**SEQUOYAH NUCLEAR PLANT (SQN) - RESPONSE TO REQUEST FOR
ADDITIONAL INFORMATION (RAI) REGARDING TECHNICAL
SPECIFICATION (TS) CHANGE 00-14, "PRESSURE TEMPERATURE LIMITS
REPORT (PTLR) AND REQUEST FOR EXEMPTION FROM THE REQUIREMENTS
OF 10 CFR 50, APPENDIX G," (TAC NOS. MB6436 AND MB6437)**

SEQUOYAH NUCLEAR PLANT (SQN) RESPONSE TO REQUEST FOR ADDITIONAL INFORMATION (RAI)

TECHNICAL SPECIFICATION (TS) CHANGE NO. 00-14,
DOCKET NOS. 50-327 AND 50-328

Figure 1-1
Finite Element Model for Closure Head Region,
Sequoyah Units 1 and 2

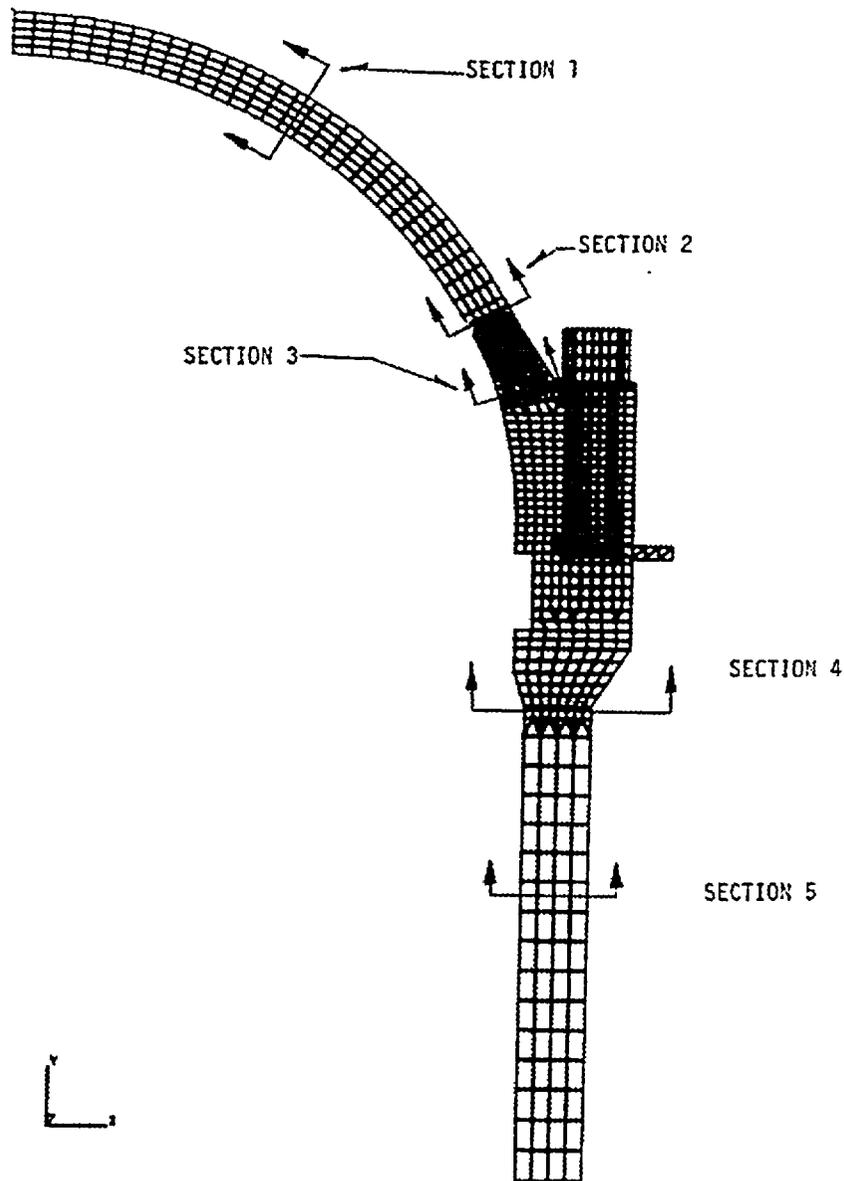
Regarding the discussion on page 4-1, "These results [the stresses for boltup and steady-state operation given in Table 4-1] were taken from a finite element analysis of the heatup/cooldown process, and the boltup was determined to be the most limiting time step for the entire heatup/cooldown transient."

Provide a summary which identifies how the finite element analysis (FEA) was performed, including important analysis variables (e.g., mesh size/element used, convergence criteria, thermal transient time step magnitude, boundary conditions, etc.). The level of detail provided should be such that the U.S. Nuclear Regulatory Commission (NRC) staff will have reasonable assurance regarding the acceptability of the licensee's FEA process and input variables. Provide stress analysis results consistent with the level of detail provided in Table 4-1) and through wall temperature distributions at twenty evenly distributed points along the most limiting heatup/cooldown transient which was analyzed.

The stress analysis was performed using an axisymmetric model shown in cross section in Figure 1-1, where the cross section of interest is highlighted as Section 3.

There are 54 studs that join the reactor vessel head to the closure flange. These studs are equally spaced around the vessel. Two-dimensional axisymmetric elements were used to model the closure flange region of the reactor vessel. There are a total of 996 elements and 1139 nodes in the model.

Physically, the reactor vessel shell will displace laterally, and the crown of the head does not displace laterally. To approximate this behavior, the bottom surface of the model in the shell region and the vertical surface of the model at the vessel crown were both assumed to be resting on rollers. This arrangement of restraint is assumed to correspond to the actual behavior of the vessel, and prevents any rigid body motion of the model.

Choosing to couple mechanically at only the pivot location, as discussed above, should tend to increase the bending stresses at all the selected Sections 1 through 5 shown on Figure 1-1. Mechanical coupling at more than one node, or all the nodes on the flange mating surface would have prevented free rotation of the flanges, and reduced the bending stresses.

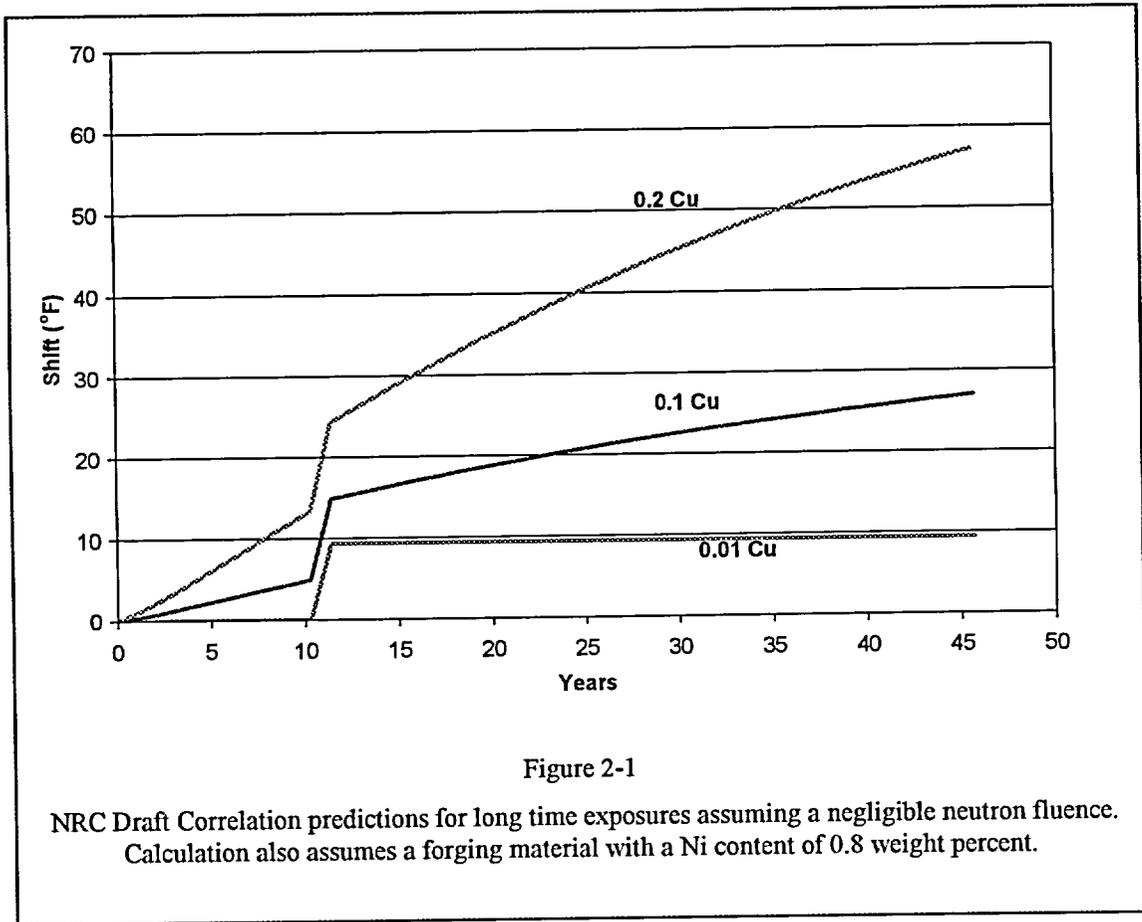
Regarding the information provided on page 4-2 on the effect of thermal aging:

- a. Provide the chemical composition (weight percent copper and nickel) of the Sequoyah, Unit 1 and Unit 2, reactor pressure vessel (RPV) closure head region materials.
- b. Recent work supported by the NRC's Office of Nuclear Regulatory Research has led to the development of new RPV embrittlement models which incorporate terms that have the effect of a "thermal aging" (time-at-temperature) function (original work documented in NUREG/CR-6551, "Improved Embrittlement Correlations for Reactor Pressure Vessel Steel"). The most recent version of the proposed embrittlement model is included below, along with suggested input value definitions:

Making the conservative assumption that the embrittlement model equation may be directly applied to the evaluation of thermal aging effects for RPV flange materials (with the effective neutron fluence set to a nominally small value), evaluate what the predicted shift in RT_{ndt} would be for the Sequoyah, Unit 1 and Unit 2, RPV closure head region materials, and provide the predicted final RT_{ndt} values for these materials at the current end of license condition for the units.

Assess what impact these values would have on the conclusions drawn in WCAP-15984 and the licensee's exemption request.

The estimates for the Sequoyah Unit 1 and 2 flange chemistries have been compiled assuming a forging material with a Ni content of 0.8 weight percent and a fluence of 10^{14} n/cm^2 . The results of

this analysis are summarized in Figure 2-1. Three different possible Cu contents are illustrated. No specific copper contents are available for the Sequoyah units, but the 0.2 Cu level exceeds the level normally expected in RPV Forgings.

From this result, it can be seen that the effect of thermal aging on the head material is small.
